NF EN 294

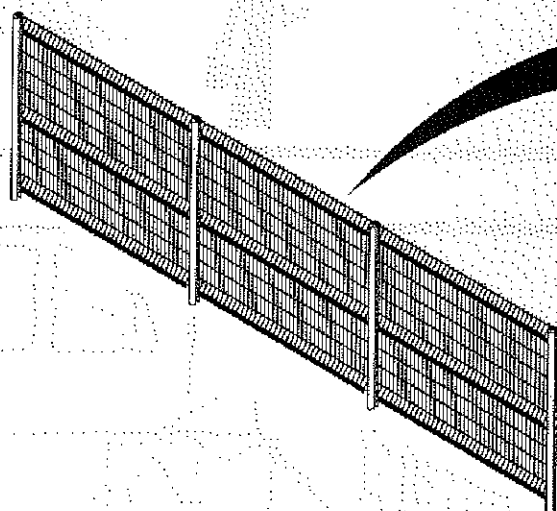
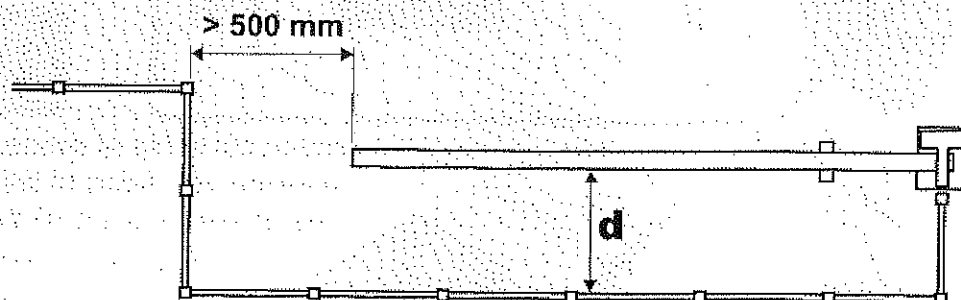
écarter entre Actuel
de 150 mm
il faudrait 900 mm
